Subject: CHECK ENGINE LIGHT ON WITH DTC P2610 AND P2507	Bulletin No: 01-018/15
	Last Issued: 08/06/2015

- This bulletin supersedes the previous bulletin 01-001/13 issued on 01/07/13, 01/16/13 and 09/25/13 and 01-017/14 issued on 10/17/14. The APPLICABLE MODEL(S)/VINS, DESCRIPTION, REPAIR PROCEDURE and WARRANTY INFORMATION have been revised.
- Changes are noted below in Red beside the change bar.

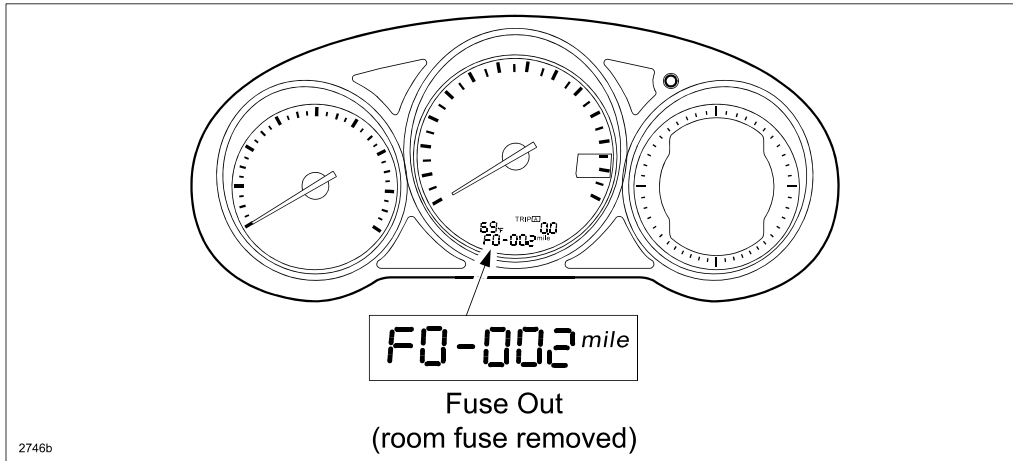
Some vehicles may experience the CHECK ENGINE LIGHT ON with DTC P2610 and P2507 stored in memory after engine start and room fuse 15A (A) removed.

As a past malfunction, the customer will not notice it (no warning light illuminated), but the DTC may be found during a vehicle service. P2507 in this situation is only applicable on 2016 and later models.

This is caused by the engine being started 3 or more times after a short duration of engine off (less than 15 seconds) with the room fuse removed.

NOTE: The odometer will display "F0-002" during transport mode (room fuse 15A removed). Transport mode is canceled when room fuse 15A is installed or the vehicle odometer is more than 12.4mi (20km).

1. Verify DTC P2610 and P2507 are stored in PCM memory.
2. Install ROOM fuse 15A with ignition OFF.
3. Start the engine and let it run for at least 10 seconds, then stop the engine.
4. Start the engine again and verify that the CHECK ENGINE LIGHT is not illuminated, then stop the engine.
5. Clear DTC P2610 and P2507 from PCM memory using IDS.
6. Verify no other DTCs are stored in memory. If so, troubleshoot them according to the MS3 online instructions or Workshop Manual.
